**PASSPORT DOCUMENT**

SUBJECT: NUQAP Topical Report Revision 22, Change 1  
(Document No. MP-02-OST-BAP01)

## Summary of Changes to NUQAP Rev. 22 Incorporated as Change 1

#### 1.7 SUCCESSION OF RESPONSIBILITY FOR OVERALL PLANT OPERATION

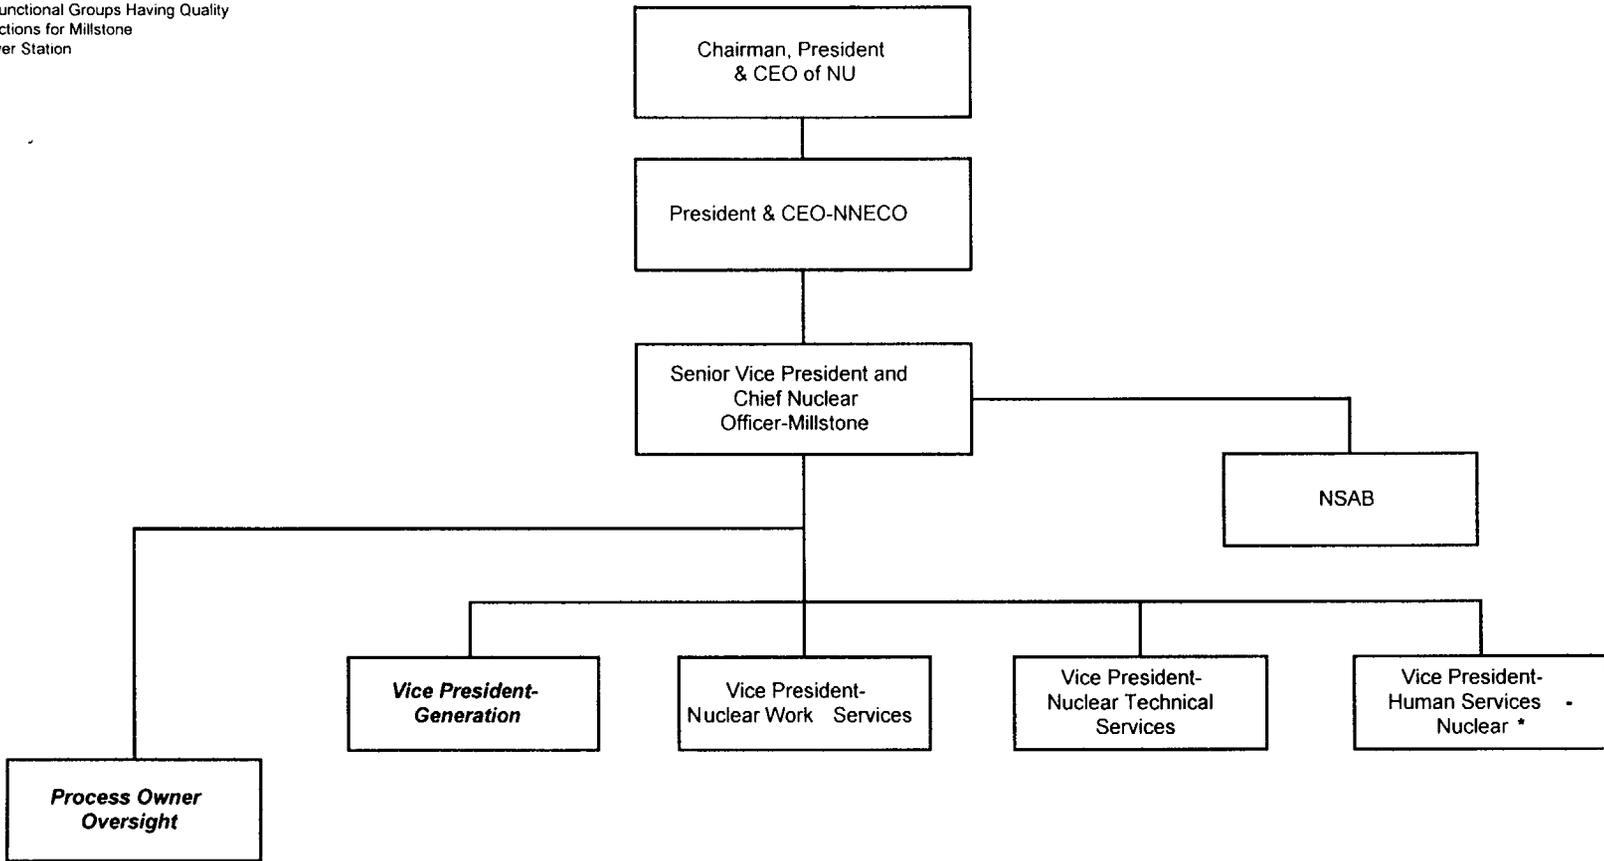
- Vice President-**Generation**
- **Master Process Owner - Operate the Asset**
- Licensed **Process Owner** - Operations or Licensed Assistant Manager-Operations designated by Vice President-**Generation**
- Shift Manager (SRO)
- Licensed Unit Supervisor (SRO)

Organizational Relationship  
of Functional Groups Having Quality  
Functions for Millstone  
Power Station

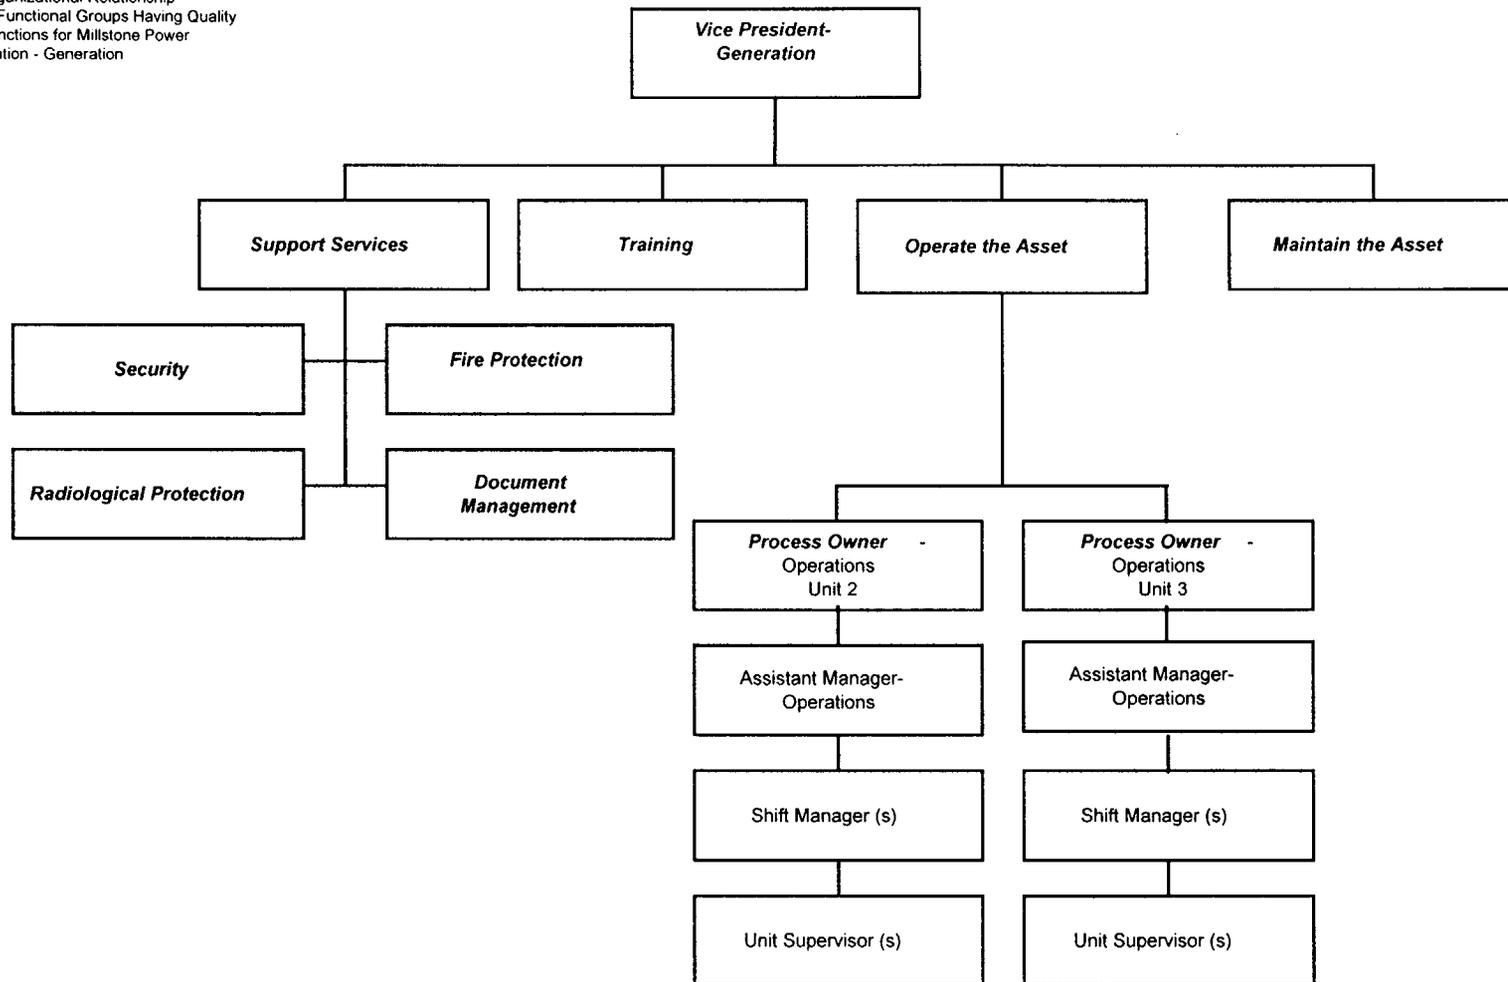
The following organization charts are incorporated by reference in the Millstone Station Emergency Plan. Changes to these organization charts require an effectiveness review in accordance with 10 CFR 50.54 (q).
